**CITY OF YPSILANTI**
**Planning Commission MEETING**
**Wednesday, May 17, 2023 @ 7:00 PM**
~~**Council Chambers**~~
~~**One South Huron, Ypsilanti, MI 48197**~~

**11 - 26** A. 20 Emerick | Limited Site Plan and Special Use Review
Staff Review | Proposed Auto Body and Repair Business

**Staff Review**
**Special Use and Site Plan Applications**
**20 Emerick**

**Figure 4 | Site Proposal for Comparison**

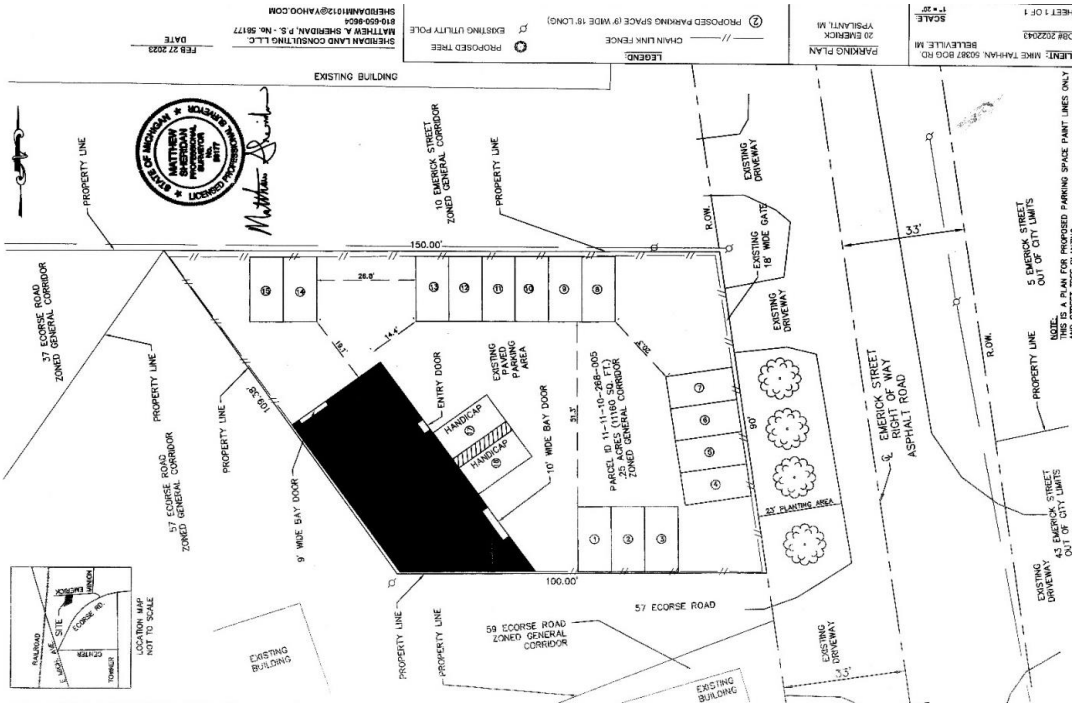
**COMMENTS** The applicant proposes to change the use of the existing building from office to auto body repair. The site improvements and proposed use will fully comply with the City's zoning ordinance.

**Figure 3 | Limited Site Plan Capture (detail)**

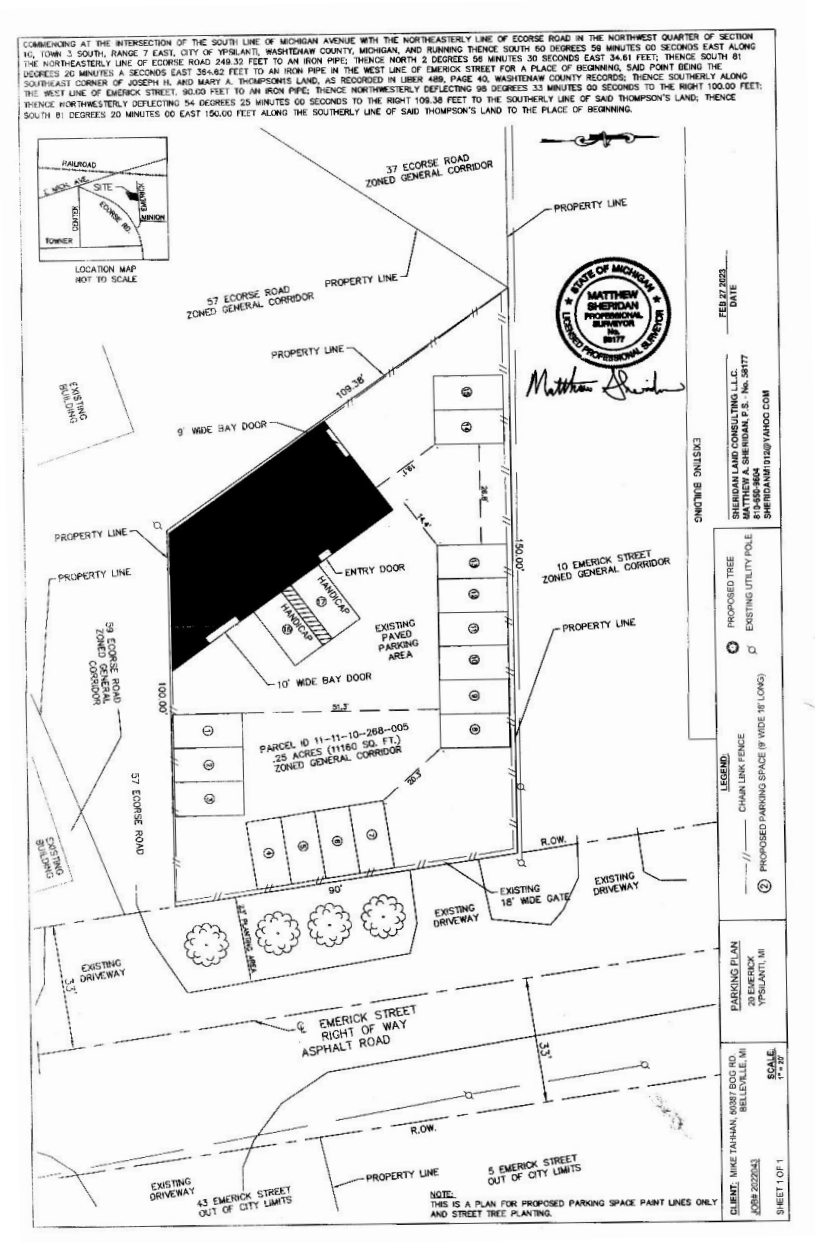
**Items to be addressed –** Curbing, wheel stops and sidewalk required. Street trees required.

**Items to be addressed –**

1. Applicant shall provide a plan for trash storage area. Any new or altered commercial use, including residential uses with three or more units, which requires zoning compliance review and has an outdoor trash storage area must comply with the following requirements:

2. Lighting plan / photometric plan required.

1. Applicant must provide trash storage plan.
2. Applicant must provide photometric / lighting plan.
3. Applicant must provide wheel stops in parking spaces.
4. Applicant must provide sidewalk.
5. The entire lot, excluding areas occupied by landscaping and building, must be hard-surfaced with concrete or plant-mixed bituminous material. Curbs of at least six inches in height must be installed around the perimeter of all surfaced areas. Drainage must be provided in accordance with §122-683.
